August 2025 | Public Draft

The Mosaic Project

Final EIR

for Alameda County

Figure 3-2a
Local Context

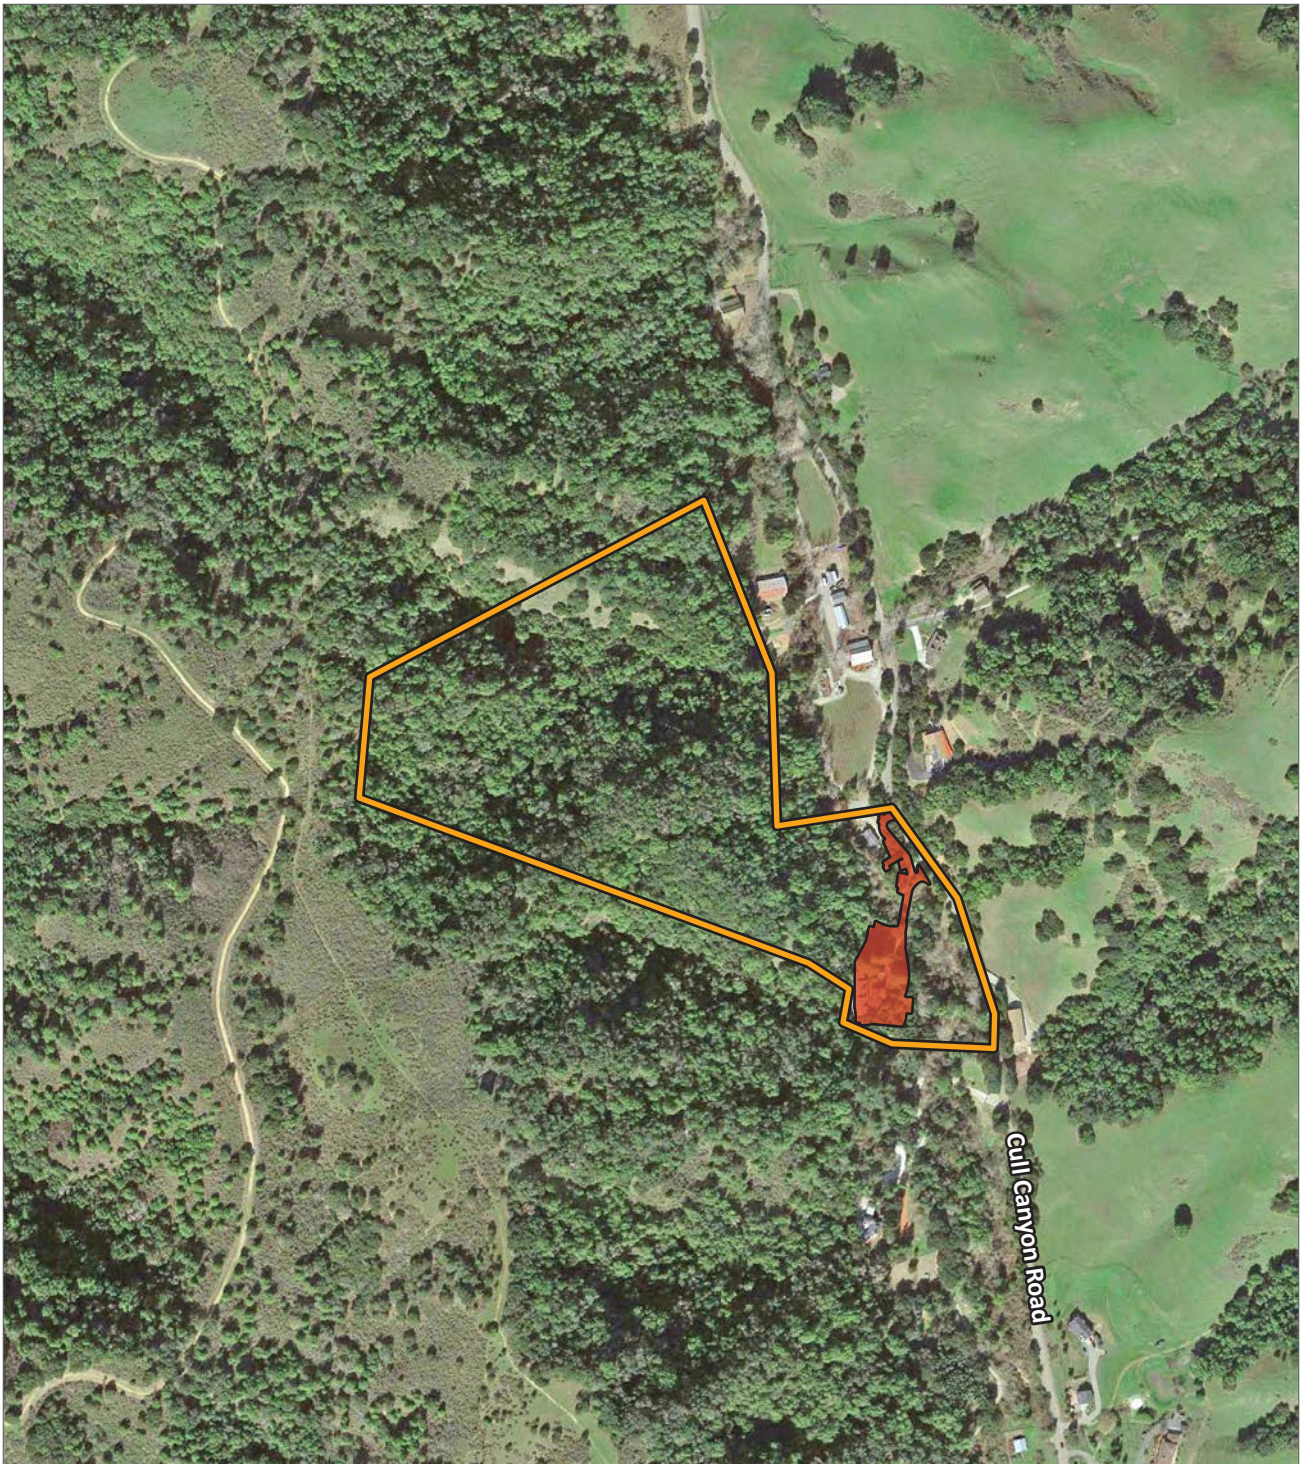
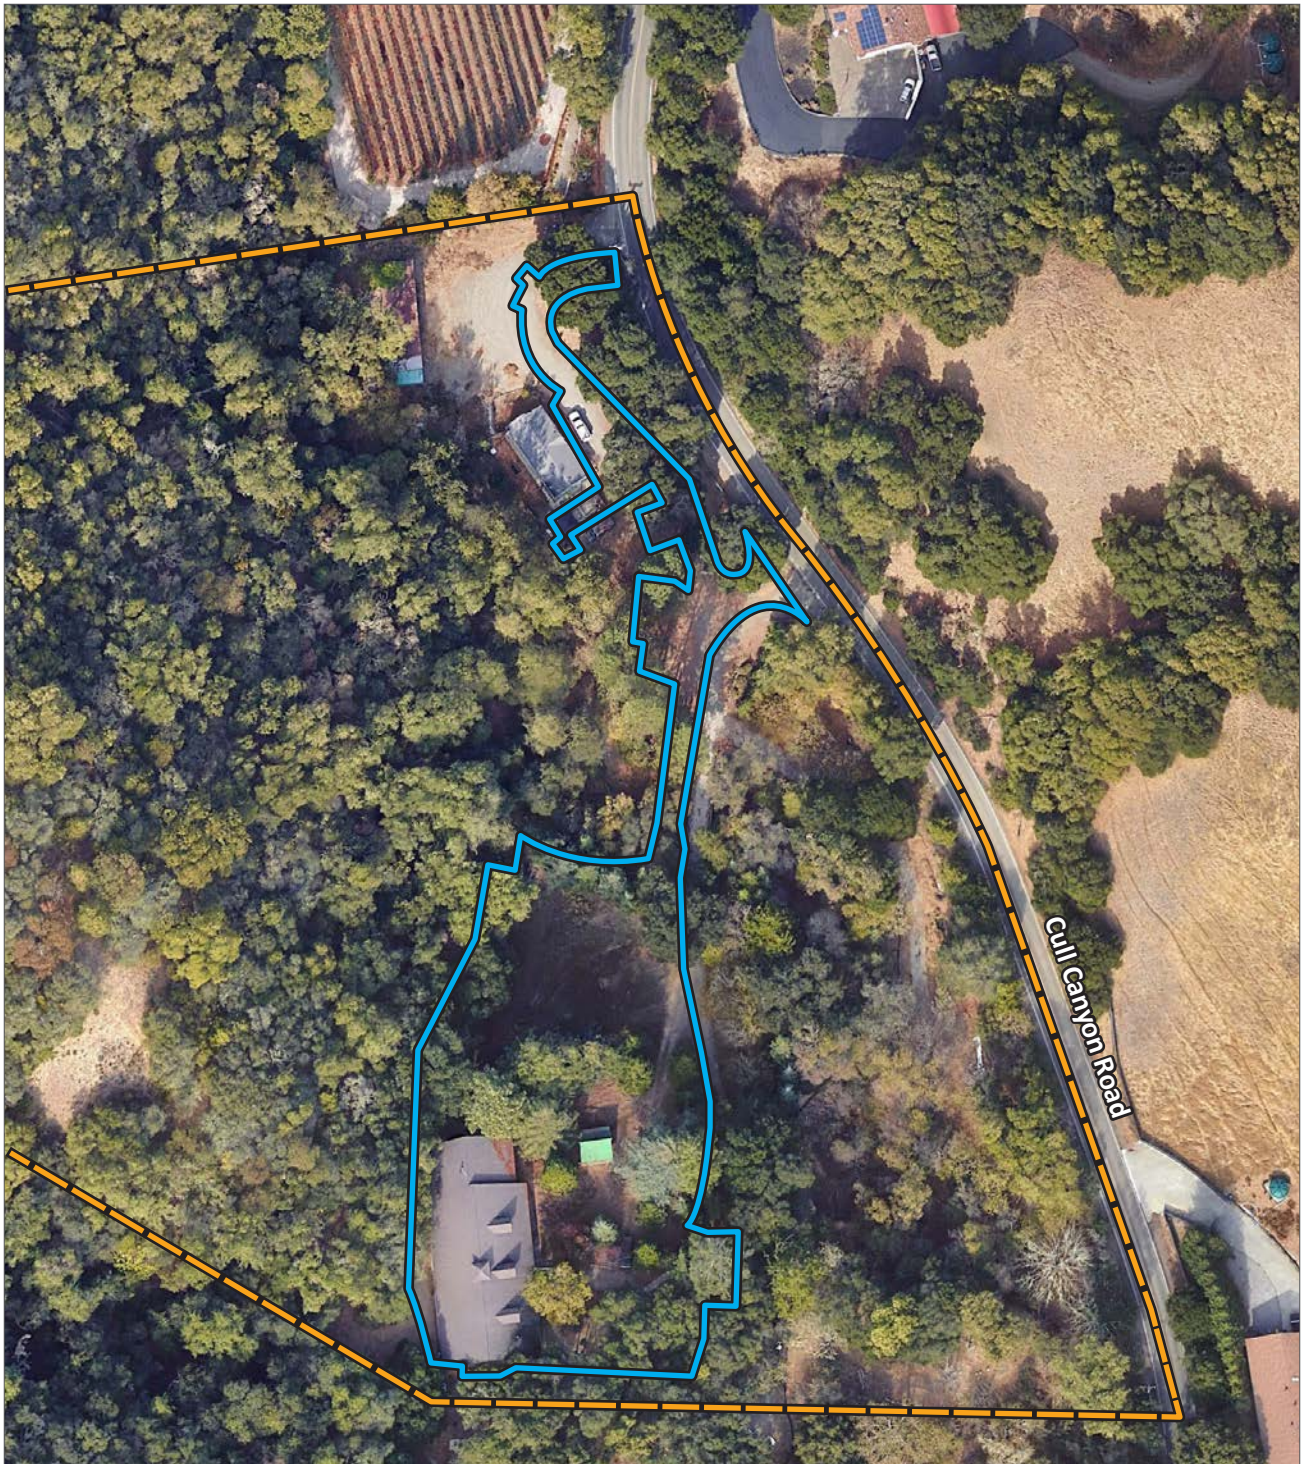
Figure 3-2, *Local Context*, on page 3-5 of the Revised Draft EIR is hereby revised and renumbered to Figure 3-2a and a new figure (Figure 3-2b, Proposed 2-Acre Development Area) is hereby added after page 3-5:

Figure 3-2a, *Local Context*, shows the immediate vicinity of the project site. The project site is within a largely undeveloped area. Residential land uses are located east, south, and west of the project site; the Twining Vine Winery ~~and Event Center~~ is located to the north; and East Bay Regional Parkland is adjacent to the agricultural properties located along the western boundary. Within the Eastbay Regional Parkland, and bordering the project site to the west, is the Juan Bautista de Anza Historic Trail that stretches from the San Francisco Bay Area to Nogales, Arizona.
